TENNESSEE VALLEY AUTHORITY

Enclosed is our supplemental response to R. C. Lewis' May 2, 1984 letter to H. G. Parris regarding our June 4, 1984 response to Inspection Report Nos. 50-259/84-12, 50-260/84-12, 50-296/84-12 for the Browns Ferry Nuclear Plant. This response provides supplemental information for Violations 1 and 2 as requested in your May 2 letter. A two-day extension to August 17 was discussed between Ross Butcher of your staff and Mike Hellums of my staff on August 15, 1984. If you have any questions, please call Jim Domer at FTS 858-2725.

ENCLOSURE
SUPPLEMENTAL RESPONSE
NRC INSPECTION REPORT NOS.
50-259/84-12, 50-260/84-12, AND 50-296/84-12,
RICHARD C. LEWIS' LETTER TO H. G. PARRIS
DATED MAY 2, 1984

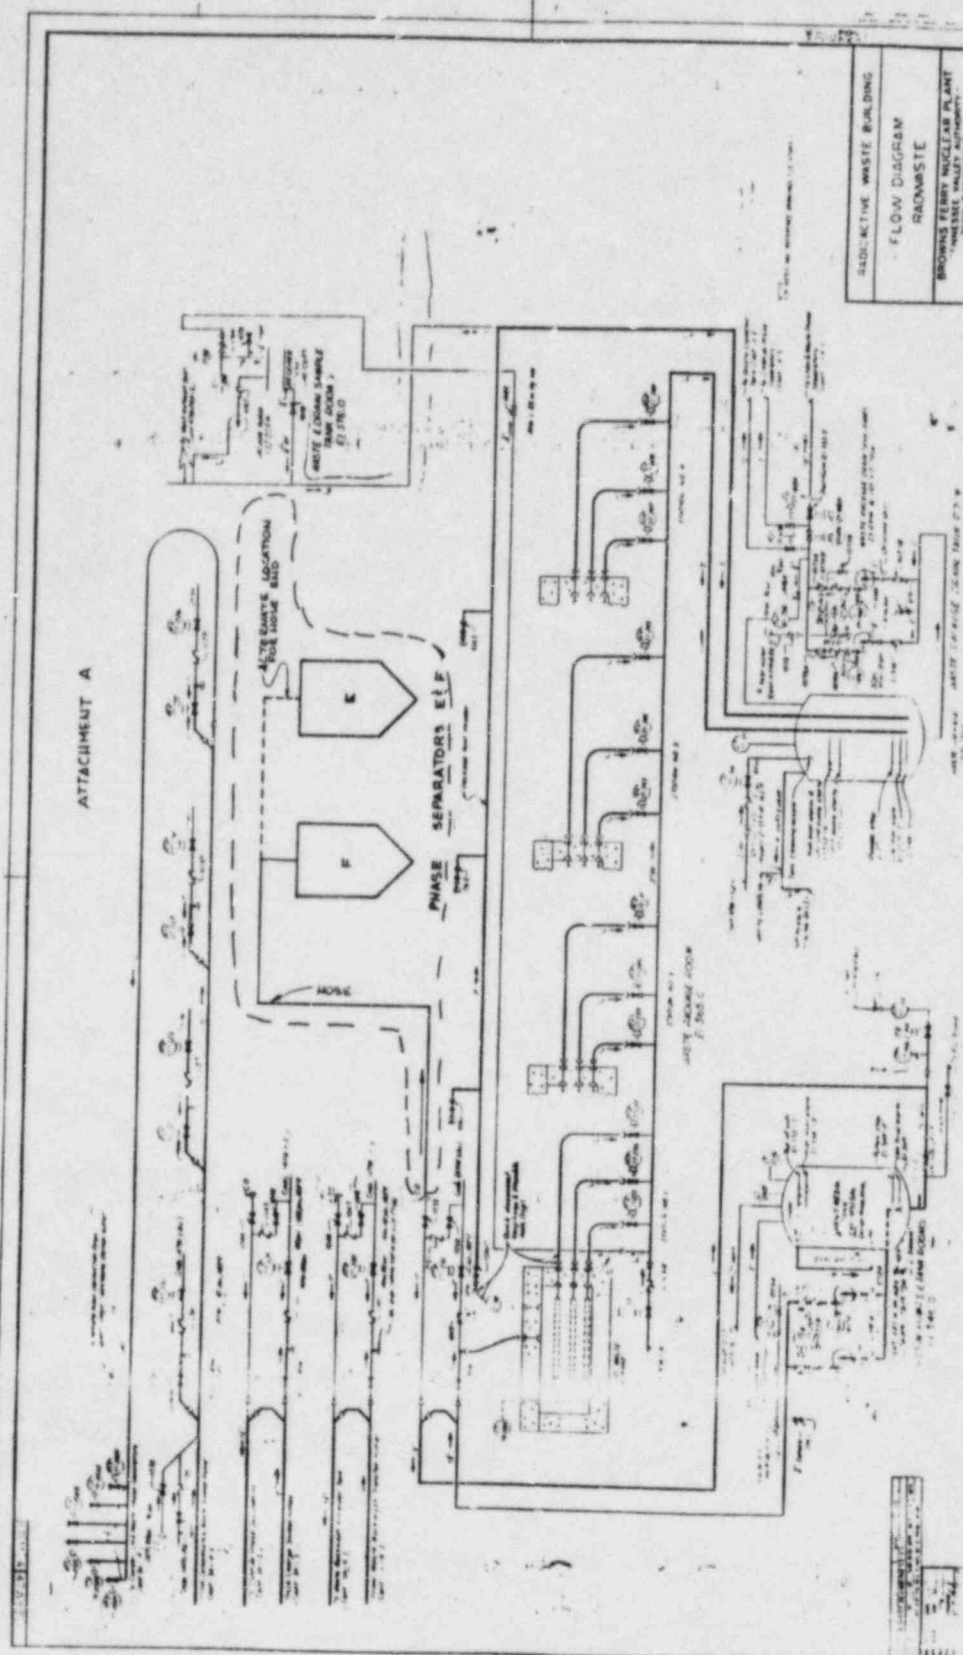
Attachment B is a copy of figure 9.3-1A marked to show the use of permanently installed hose connections to route bead resin from the spent resin packaging outlet to a common line leading to all six waste phase separators (A - F). The arrangement shown on attachment A was not evaluated to determine if an unreviewed safety question (10 CFR 50.59 evaluation) existed at the time of installation. Once plant personnel became aware of this oversight, a 10 CFR 50.59 evaluation was performed.

The key factor in performing the 10 CFR 50.59 evaluation was that the final result from using the configuration shown in attachment A is the same as from using the approved configuration shown on attachment B. Our evaluation was further confirmed in a memorandum from TVA Engineering Design that states: ' . . . The design of the radwaste system did not preclude mixing of bead resin and powdered resin in a liner prior to disposal. An existing hose connection also allows upstream mixing in the phase separators. . . . '

ATTACHMENT B

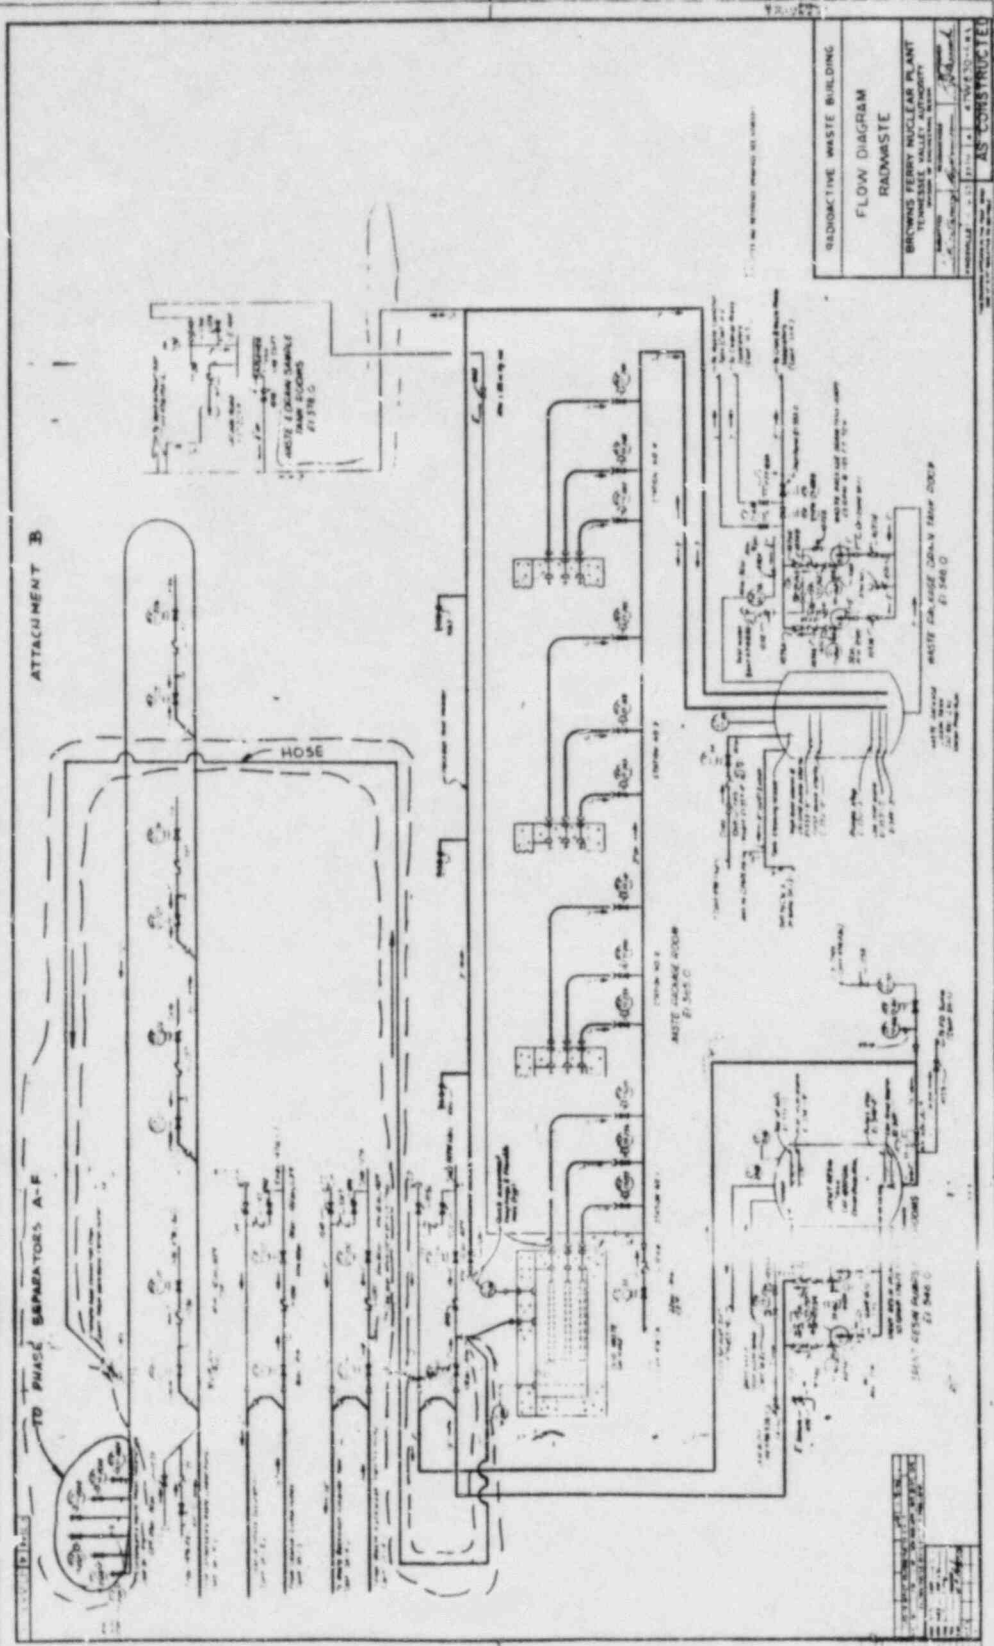
Section 9.3 of the FSAR contains both a written description of the solid radwaste system and a flow drawing (figure 9.3-1A). This figure agrees with the text and shows both bead and powdered resin slurries being routed to the common waste packaging area. The figure contains small details such as hose connections, flush lines, and liner internals not mentioned in the text. Just because these details are not mentioned in the text does not lessen their importance, nor does it prohibit their use in meeting the systems design basis. It is Browns Ferry's use of these small details that require further clarification. Attachment A is a copy of figure 9.3-1A marked to show how plant personnel attached a reinforced rubber hose to transfer bead resin to waste phase separators 'E' or 'F.' It is clearly evident that the connection was made through a flush line and flow was in a direction opposite to that shown. This configuration is still in use and is preferred by plant personnel. Because the free end of the hose can only reside in one phase separator at a time, administrative control over bead resin mixing is maximized.

safety question determination is dependent on the details of the proposed changes. In this particular case, we believe that mixing of the resin types is within the scope of the FSAR description, and that an unreviewed safety question determination was not required.
